Service Bulletin

Bulletin No.: 16-NA-014

Subject: Delayed Engagement After Sitting With Engine Off

4358775

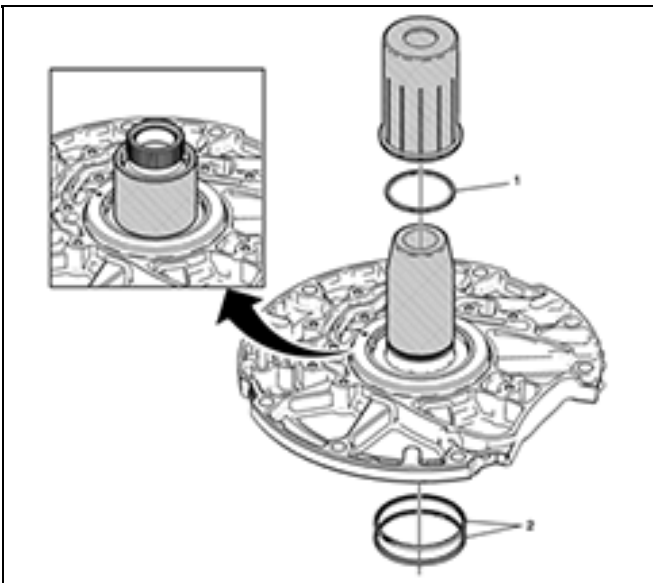
(A) Old stator support asm

(B) New stator support asm

Note: The new stator shaft support assembly has a second check ball (1) added (see illustrations).

Install a new stator shaft support assembly that includes an additional check ball. Follow the instructions below to replace the stator shaft support assembly.

4358782

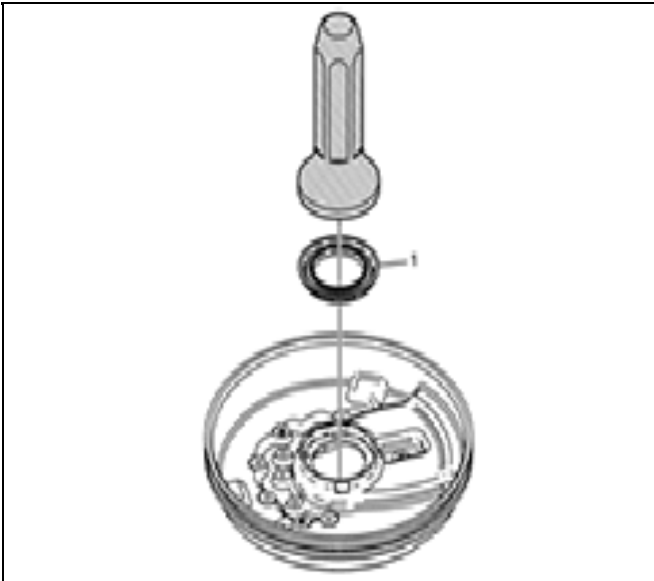
(A) Old cover - 8L90 Only

(B) New cover - 8L90 Only

Note: The casting void has been eliminated from the underside of the cover for the 8L90 only (see illustration). The 8L45 is not required.
